**Pier 26 Upland Park Construction – General Construction  
Project/Contract #C4891-A  
Addendum # 4  
December 3, 2018**

**(A) "1. C4891 –A-E Pier 26 Upland Park Construction" is amended to include the following drawing modifications:**

**AMENDED ATTACHMENT A DOCUMENTS**

L-403.00

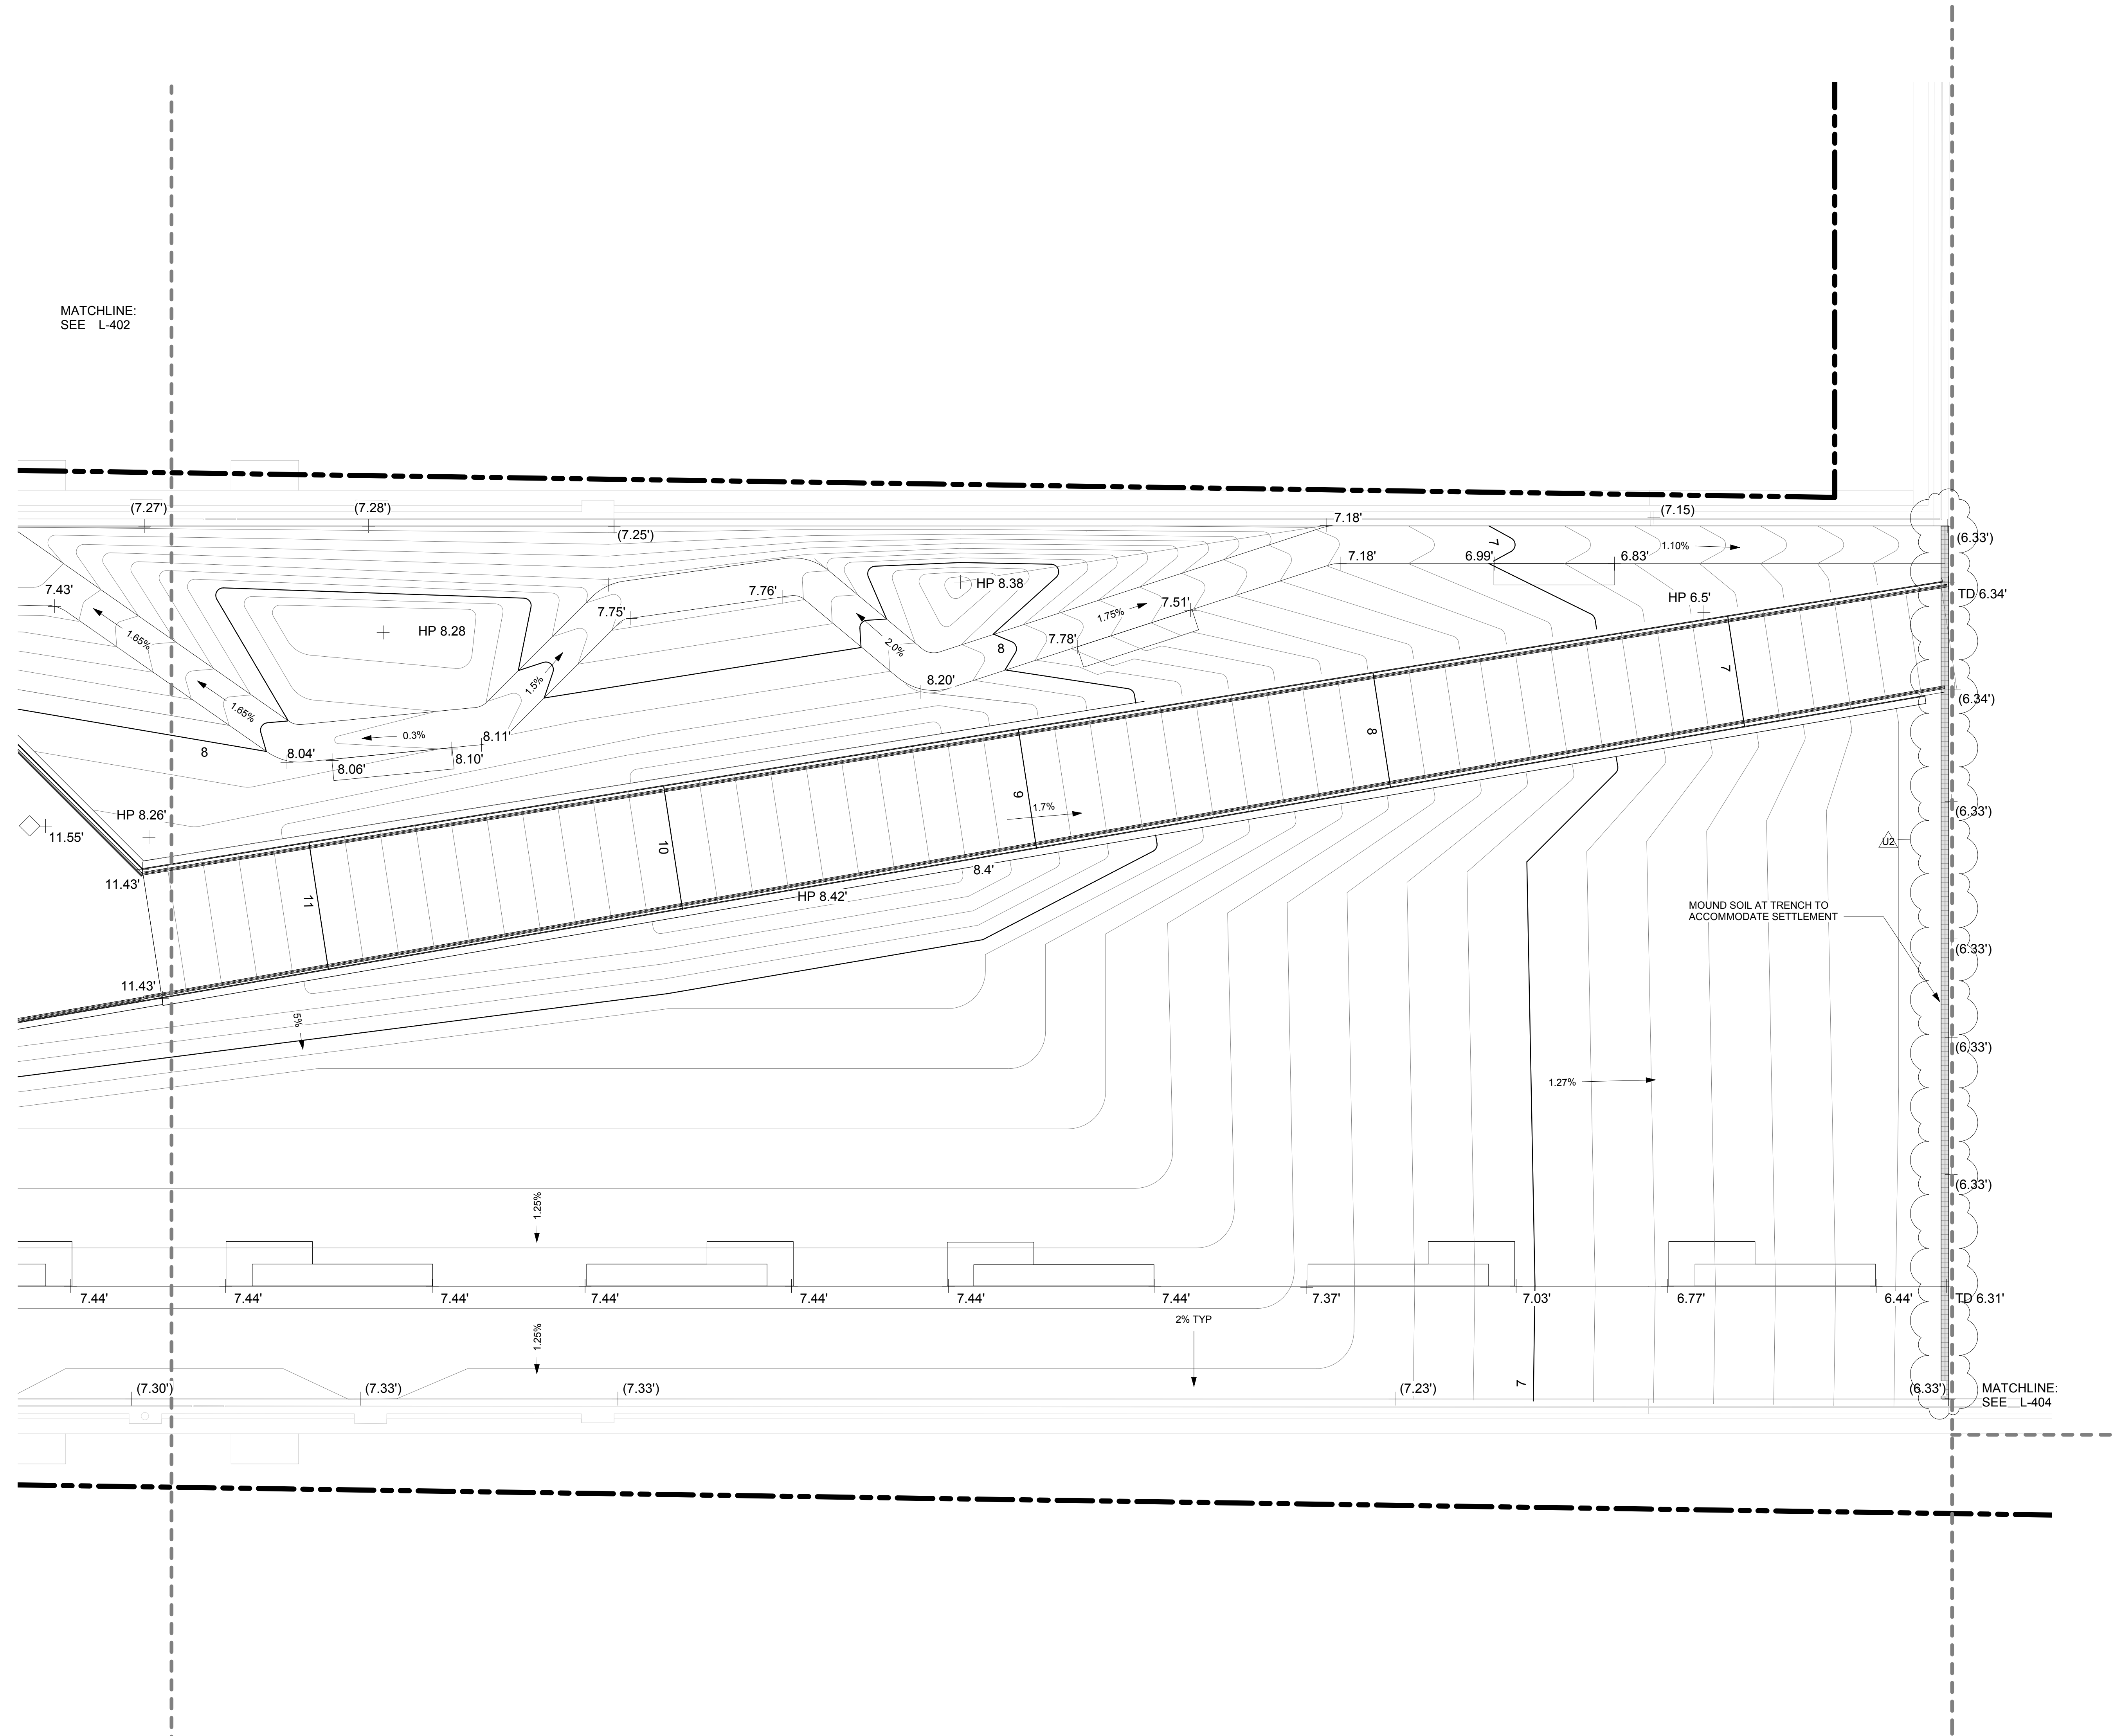
L-402 - GRADING PLAN - PIER C	Symbol for slot drain and trench drain has increased visibility.
L-403 - GRADING PLAN - PIER D	Symbol for slot drain and trench drain has increased visibility.
L-404 - GRADING PLAN - NORTH UPLAND	Symbol for slot drain and trench drain has increased visibility.
S-301 - FRAMING PLAN - PIER B	Walkway south of seating terrace no longer called out as 8" concrete seating step.
S-302 - FRAMING PLAN - PIER C	The thickness of the concrete is correctly labeled to show the 8" depth only at the 15' wide southern, as in the materials plans.
E-301 - ELECTRICAL PLAN - PIER B	Location of Q-vault shown.
E-302-ELECTRICAL PLAN - PIER C	Electrical clarification to sport pole.
E-308 - WOOD AND STEEL SHED ELECTRICAL DETAILS.pdf	New sheet showing clarifications of electrical work at the sheds.
P-303 - SANITARY PIPING PLAN - PIER D	Cross section of piping added.
P-312 - SANITARY PIPING PLAN - PIER C	Clarification to boat service utilities.
